Access Compliance Report

Public Rights-of-Way

(Curb Ramps)

Intersection ID: 45139	Main Street: SHOCCO_LN	Cross Street: FOUR_SISTERS_LN	Location: NW
ADA ID: BD1F5687B1D3	Ramp Type: BlendTrans1	Initial Pass/Fail: Fail	Overall Compliance: No
		Severity Score: 8.75	
Codes/Mitigation Info/Possible Solution		Field Measurements/Component Compliance

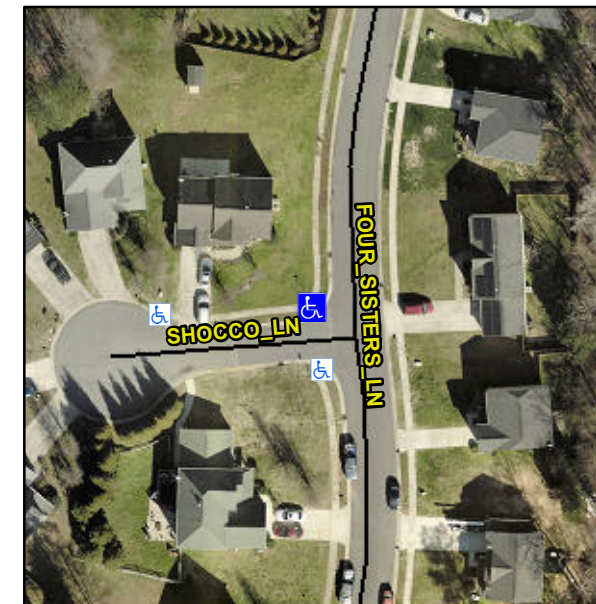
CURB LIP 0.5

Not Found, R304.5.1

Compliance	Description	Data	Compliance	Description	Data
N/A	Ramp Length (in)	45.0	Yes	BlendTrans Slope (%)	4.9
No	Ramp Width (in)	38.0	Yes	BlendTrans XSlope (%)	1.3
N/A	Flare Type LT	N/A	N/A	Flare Type RT	N/A
N/A	Flare Slope LT (%)	N/A	N/A	Flare Slope RT (%)	N/A
N/A	Flare Traversable LT?	N/A	N/A	Flare Traversable RT?	N/A
N/A	Landing Length (in)	N/A	N/A	DWS Provided?	N/A
N/A	Landing Width (in)	N/A	N/A	DWS Contrast?	N/A
N/A	Landing Slope (%)	N/A	N/A	DWS Length (in)	N/A
N/A	Landing X Slope (%)	N/A	N/A	DWS Full Width?	N/A
N/A	Landing Curb? (Y/N)	N/A	N/A	DWS Offset (in)	N/A
N/A	Shared Landing?	N/A			
N/A	Gutter Ponding?	N/A	N/A	Gutter Slope (%)	N/A
N/A	Gutter Lip Ht (in)	N/A	N/A	Gutter X Slope (%)	N/A
N/A	Painted X Walk1?	No	N/A	Painted X Walk2?	No
	X Walk 1 Direction	To S		X Walk 2 Direction	To E
	X Walk 1 Width (in)	N/A		X Walk 2 Width (in)	N/A
	X Walk 1 Slope (%)	1.5		X Walk 2 Slope (%)	1.3
	X Walk 1 X Slope (%)	3.9		X Walk 2 X Slope (%)	0.4

N/A	Ramp inside XWalk1?	N/A	N/A	Ramp inside XWalk2?	N/A
	Road Slope (%)	2.0		Clear Space?	N/A
	Road X Slope (%)	2.2	N/A	Clear Space to XWalk (in)	N/A
N/A	Any Obstructions?	N/A	N/A	Storm Grate/Utility Hazard?	N/A
	Obstruction Type			Storm Grate/Utility Type	
		N/A			N/A
			Yes	Surface Condition? (G/P)	Good
			No	Curb Slope (%)	11.6

Remove & Replace Curb Ramp With Two New Directional Ramps or Equivalent.
